AL-FAROOQ CORPORATION
ENGINEERS PLANNERS & PRODUCT TESTING

April 11, 2006

Ref: DCA 05-DEC219
E 1300-02: Glass Capacity
Legal Report Dated 3/20/06

G-6

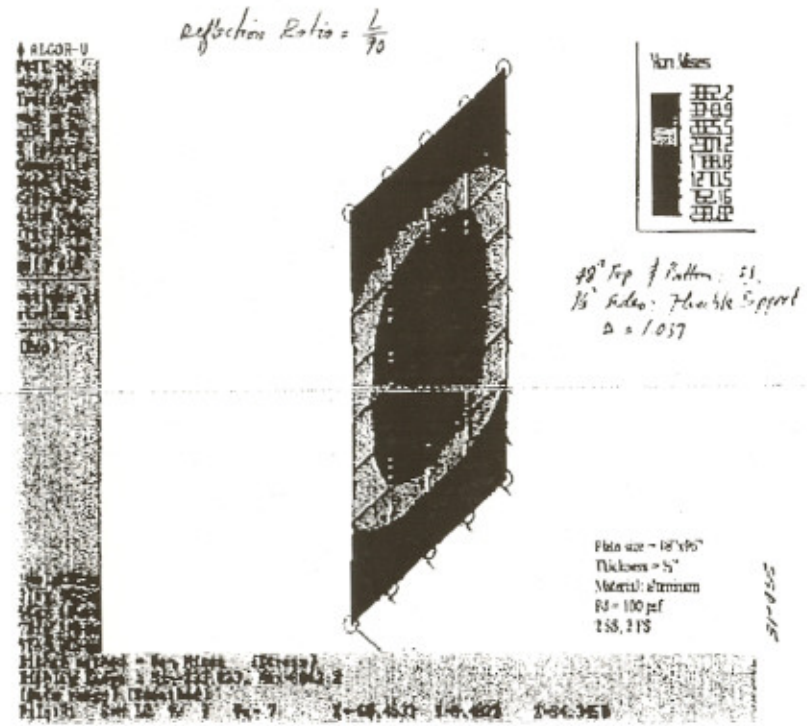
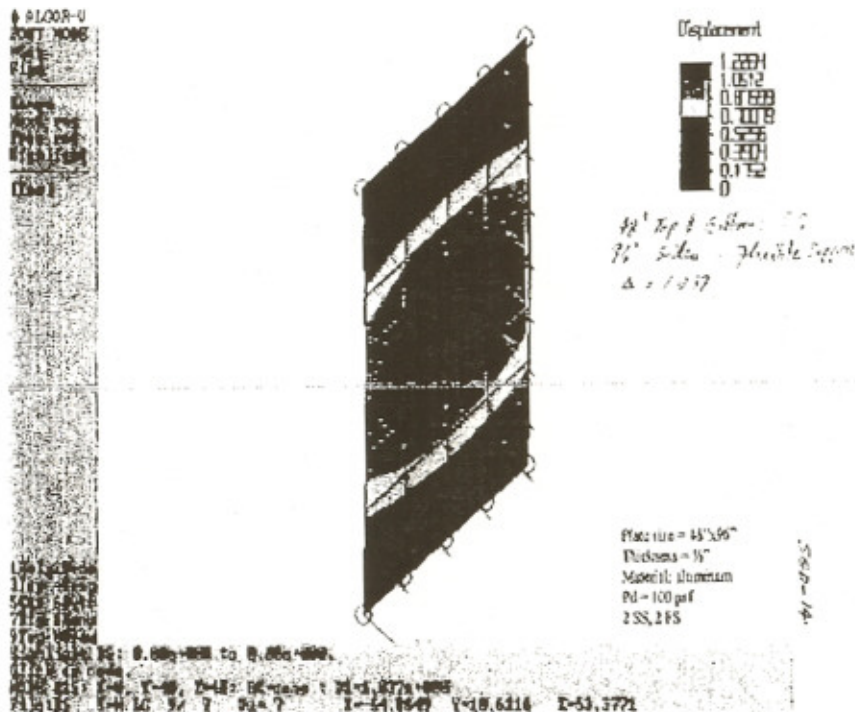
Sliding Glass Door Two Sides Flexible Support Larger Side = 96" Flexible Aspect Ratio = 2

Deflection Ratio = L/90
Overstress = 3862.2 / 3258.4 = 1.1853
Reduction Factor = 1 / Overstress = 0.8437

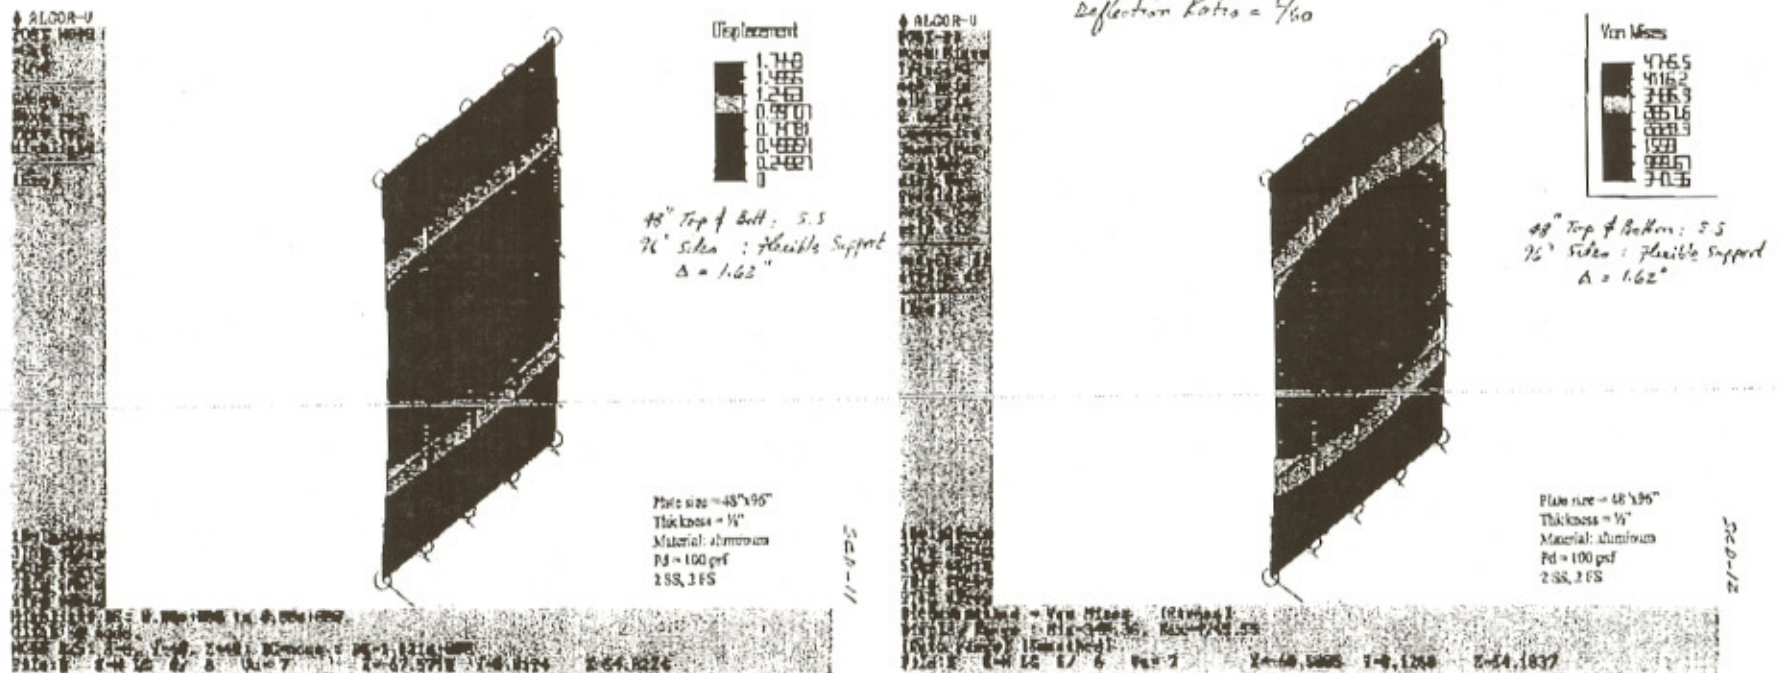
Sliding Glass Door Two Sides Flexible Support Larger Side = 96" Flexible Aspect Ratio = 2

Deflection Ratio = $L/60$
 Overstress = $4745.5 / 3258.4 = 1.4564$
 Reduction Factor = $1 / \text{Overstress} = 0.6866$

9-8

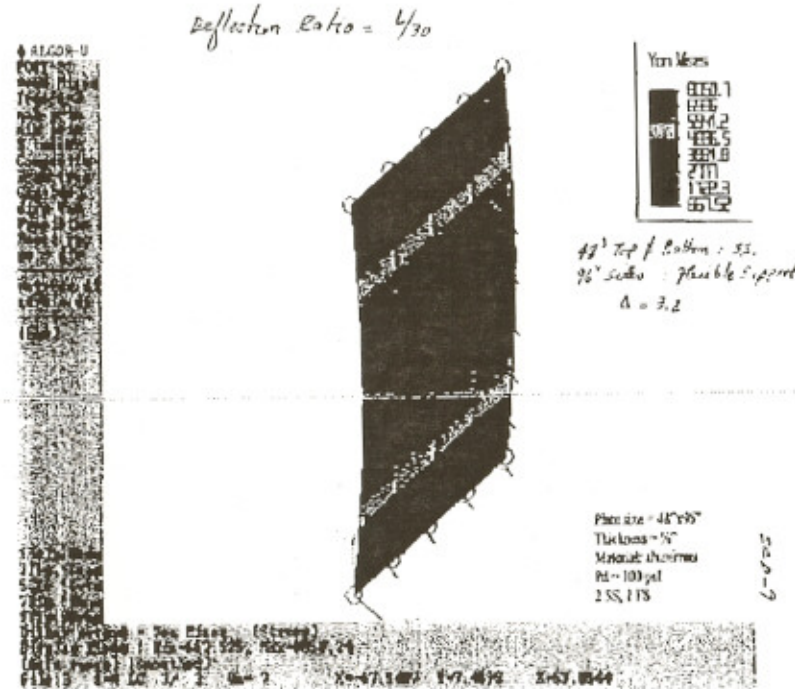
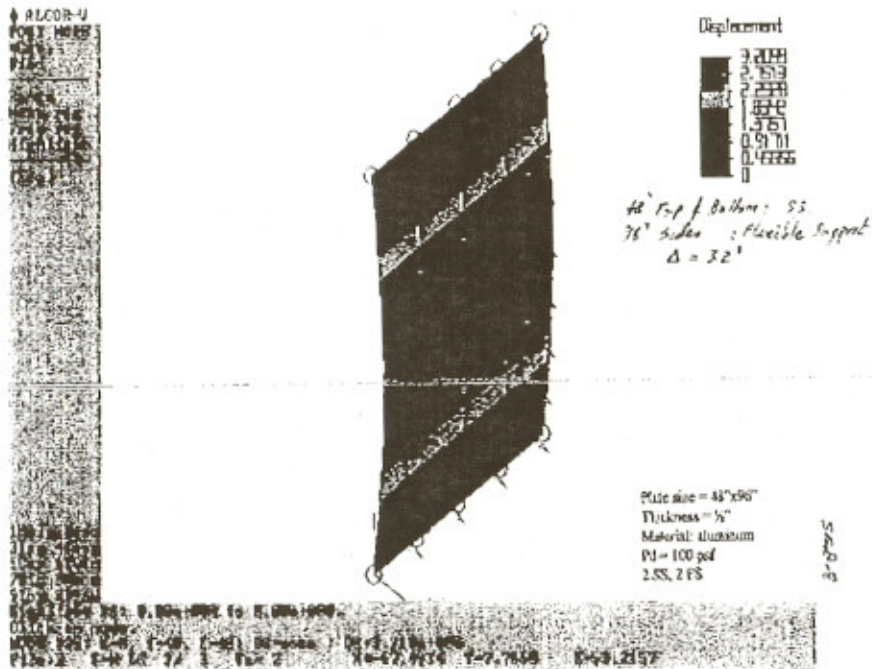
Sliding Glass Door

Two Sides Flexible Support

Larger Side = 96" Flexible

Aspect Ratio = 2

Deflection Ratio = L/30
 Overstress = 8050.7 / 3258.4 = 2.4708
 Reduction Factor = 1 / Overstress = 0.4047
